Comments on the Proposed Metals TMDL for the Los Angeles River Watershed

**A presentation to the Water Policy Task Force,
Southern California Association of Governments**

**By
Richard A. Watson, A.I.C.P.,
Consultant to Coalition for Practical Regulation**

**Los Angeles, CA
9 September 2004**

Table 31. Remaining dry-weather loading capacity for total metals for the Los Angeles River and listed tributaries (kg/day) to be allocated among stormwater and other permittees.

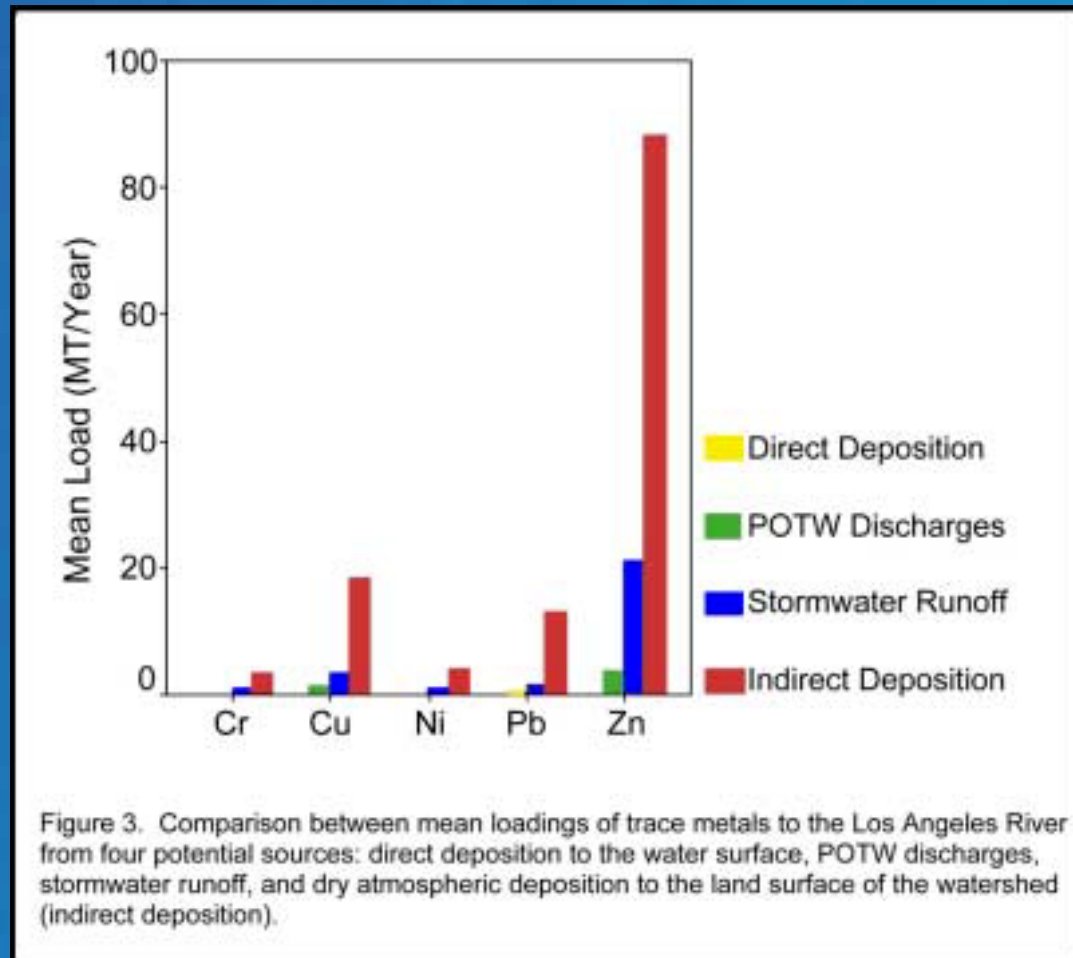
- **The stated goal is “to develop pollutant allocations for metals and an implementation plan to meet the water quality objectives in the Los Angeles River and listed tributaries.”**
- **Table 31 presents dry weather allocations for cadmium, copper, lead, and zinc for six reaches of the LA River and seven tributaries.**
- **Only 13 of the 52 allocations are waterbody/pollutant combinations listed as impairments in the 2002 303(d) list.**
- **The remaining 39 allocations should not be made. They are functionally numeric water quality objectives and TMDL numeric targets for waterbody/constituent combinations that are not listed as impaired.**

Dominance of Indirect Deposition

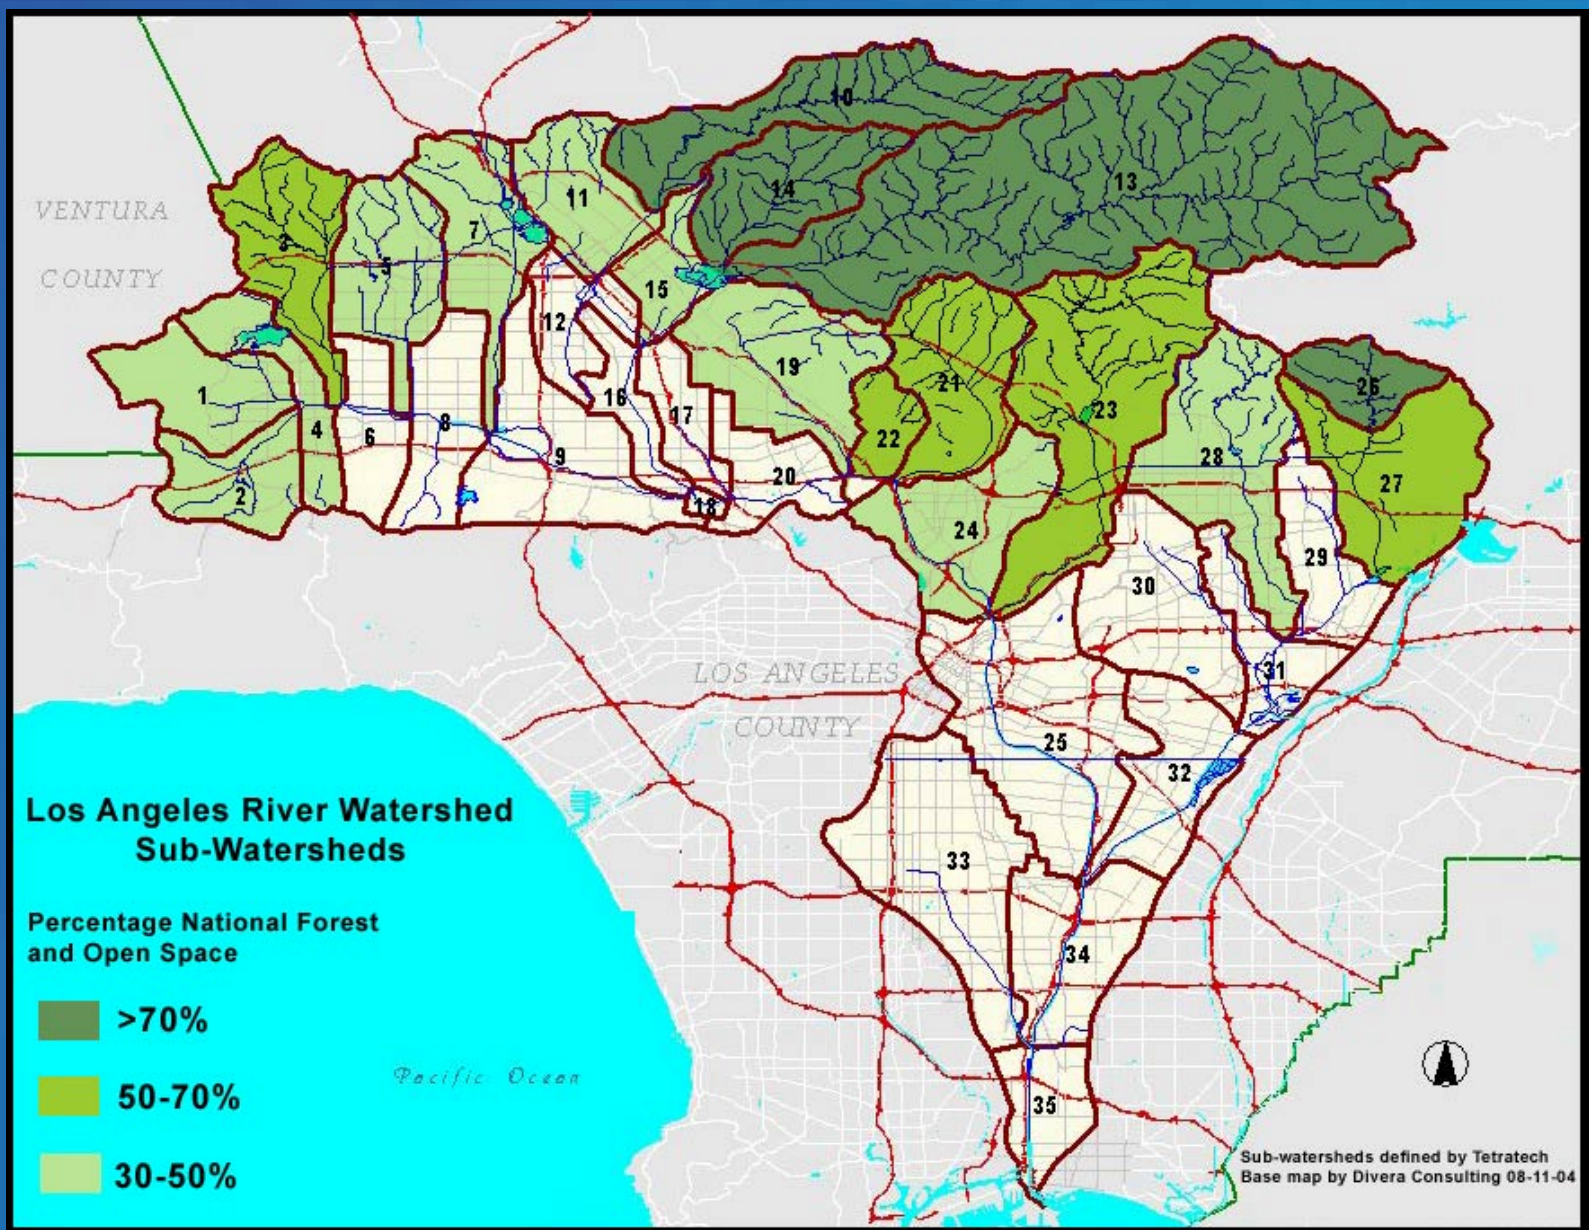
- **The staff report acknowledges that atmospheric deposition is a potential source of metals in the watershed that may contribute several thousand kilograms per year.**
- **The staff report inappropriately focuses on direct deposition in order to avoid assigning a load allocation to atmospheric deposition.**
- **The staff report makes conclusionary statements about the significance of contributions from national forests and open space in order to avoid assigning a load allocation to them.**

- **Unless the major source of pollutants is addressed, it is unlikely that the procedures described in the Implementation section of the TMDL will result in water quality standards being met.**
- **Controlling atmospheric deposition is not only a reasonable alternative consistent with the requirement of CCR Title 23 Section 3777(a), it should be the preferred alternative for the functional equivalent document.**
